**RULE NO.: R161-23.24****NOTICE OF PROPOSED RULE****POSTING DATE: October 5, 2023**

R161-23.24: Proposed revision to Standard 511-AW-02

**Rule 2 – Revisions to Standard Detail 511-AW-02**

STANDARD NO.  
**511-AW-02**  
1 OF 3

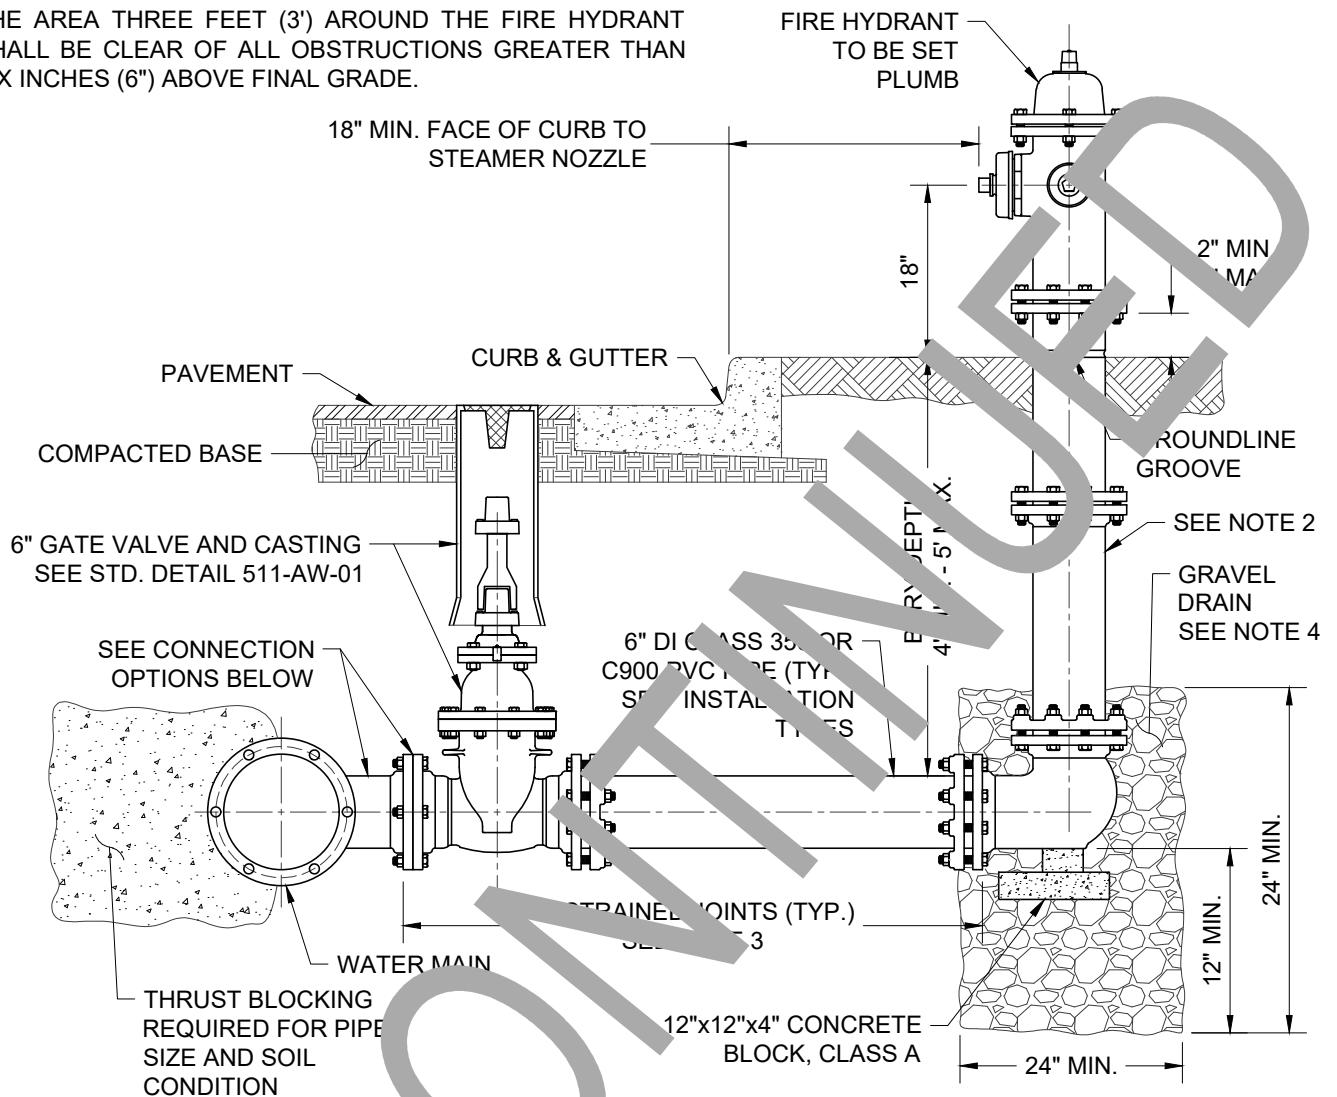
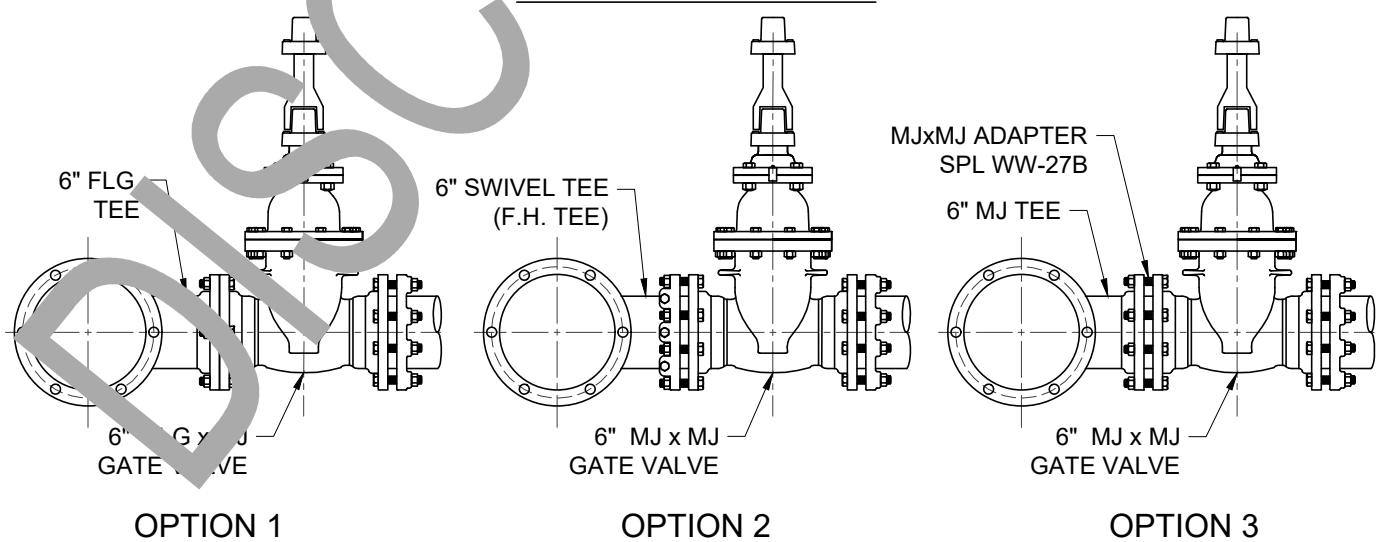
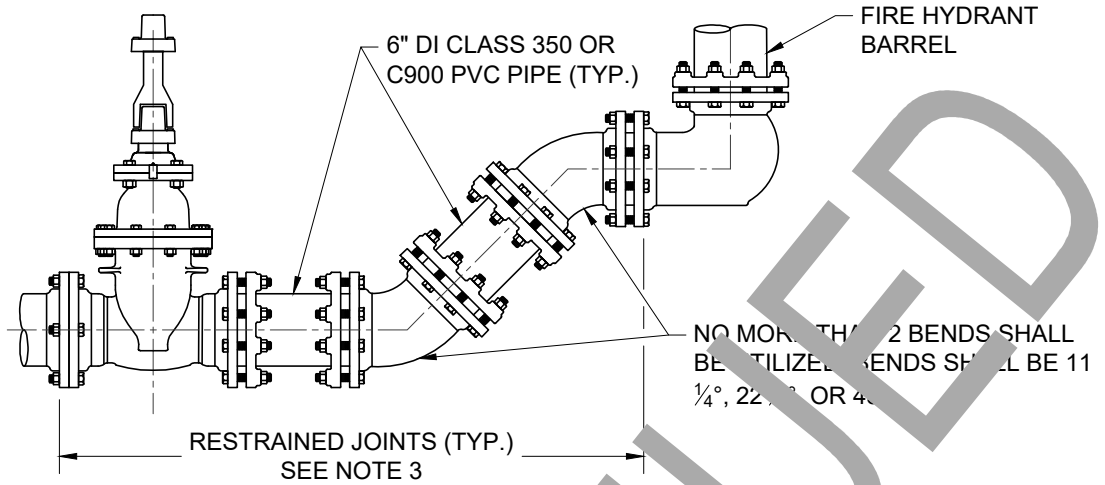
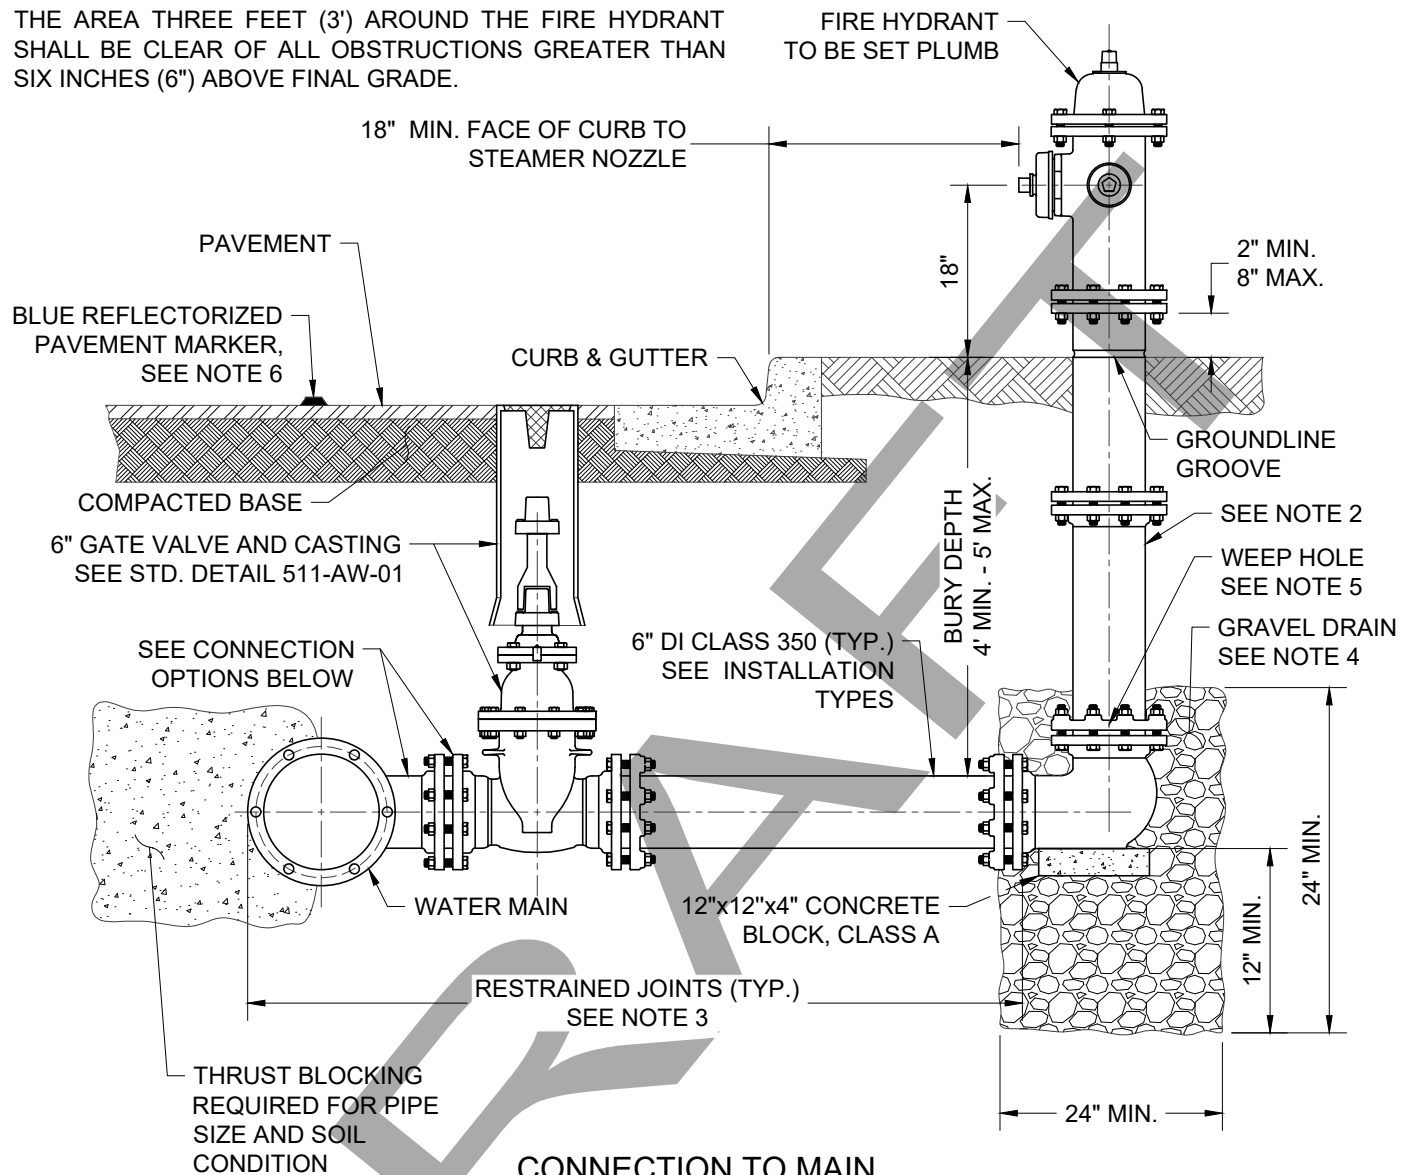
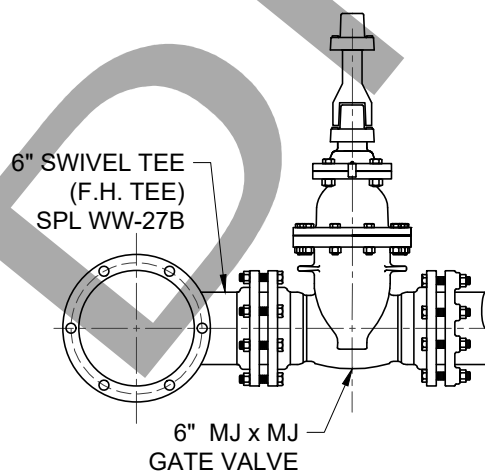
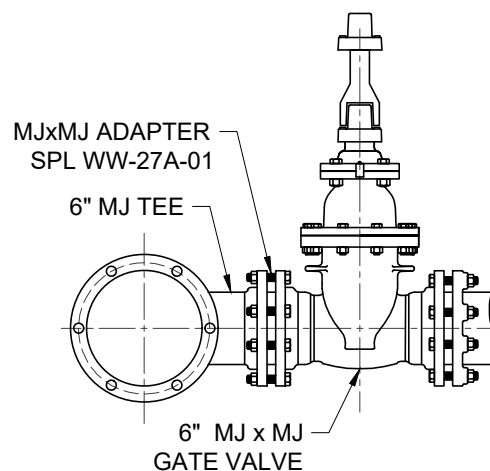
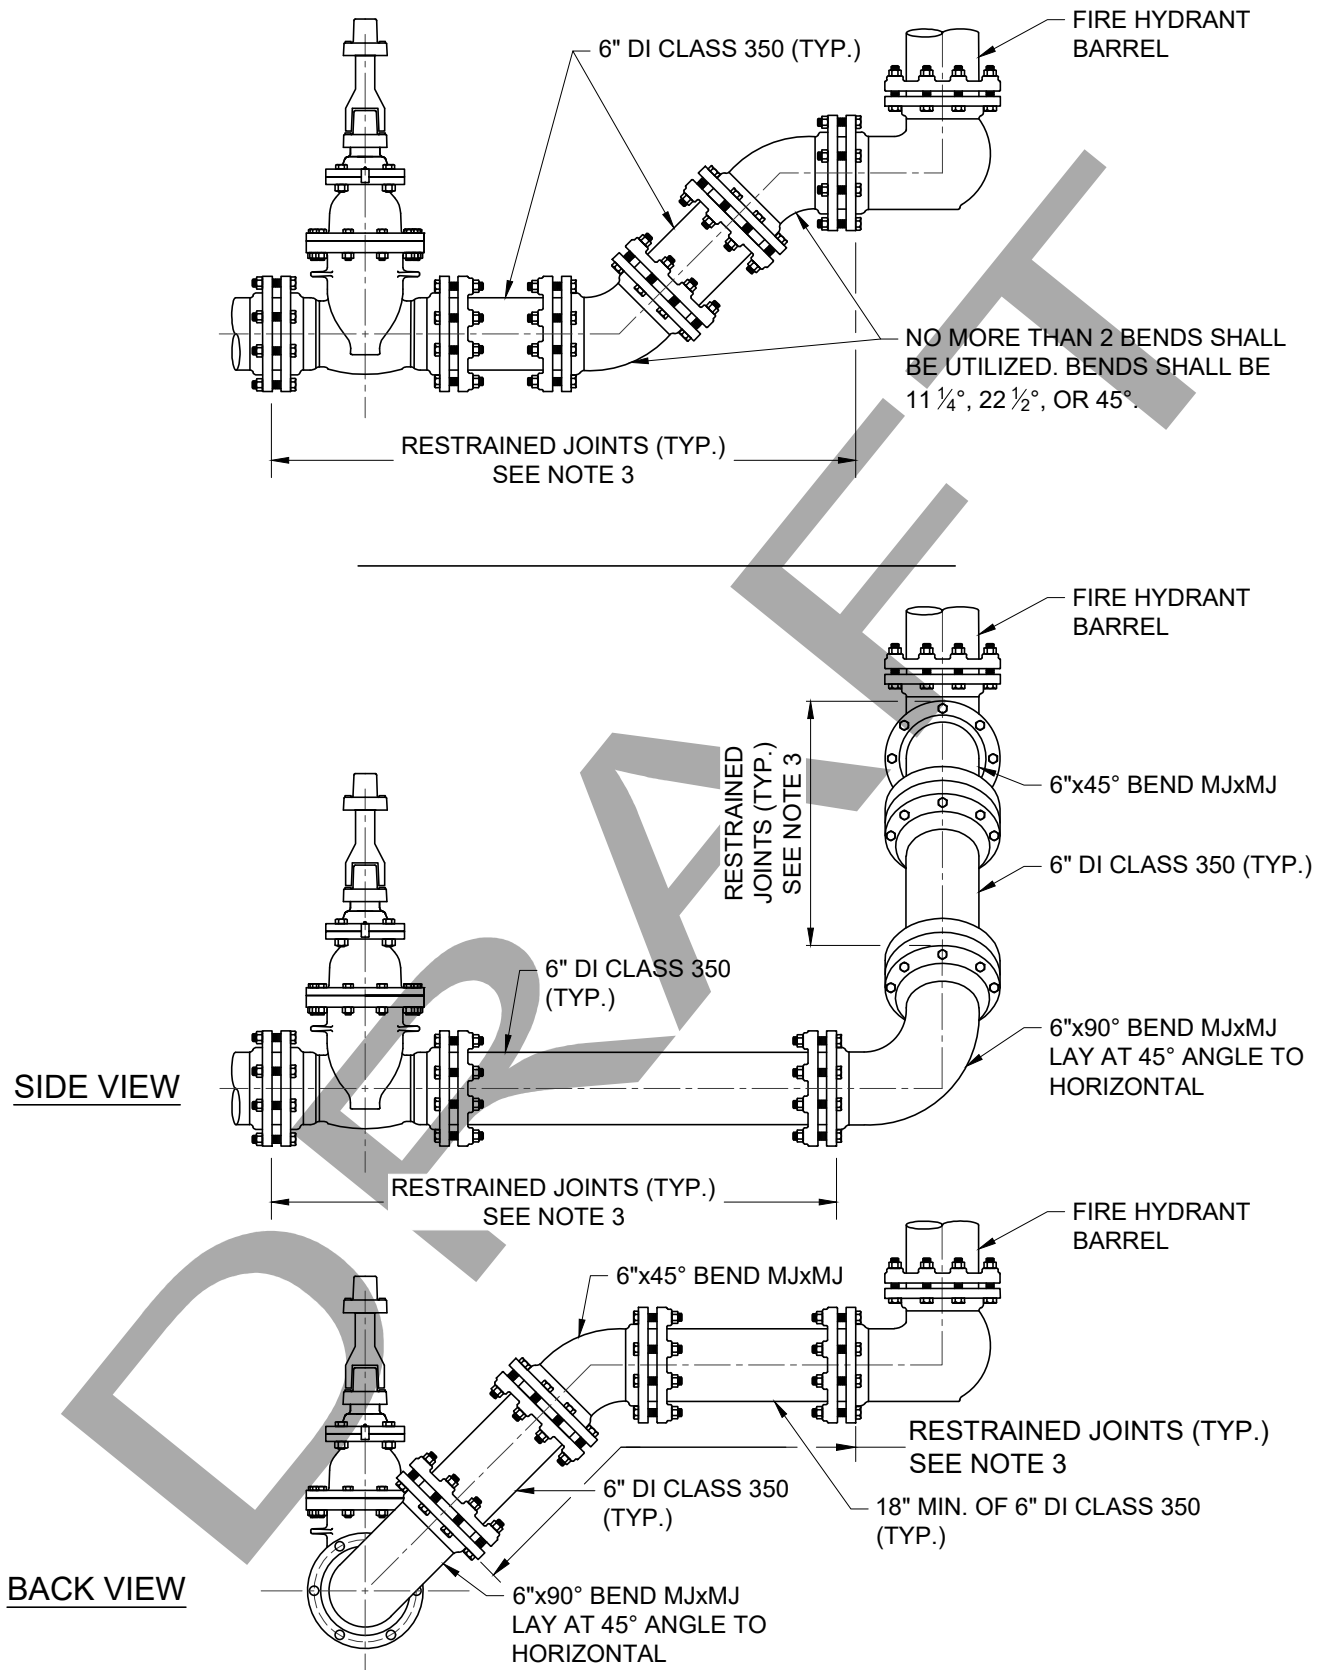
1. **Standard 511-AW-02** – We are updating this Standard to remove the PRV requirement and remove the allowance of PVC C-900, among other minor changes.
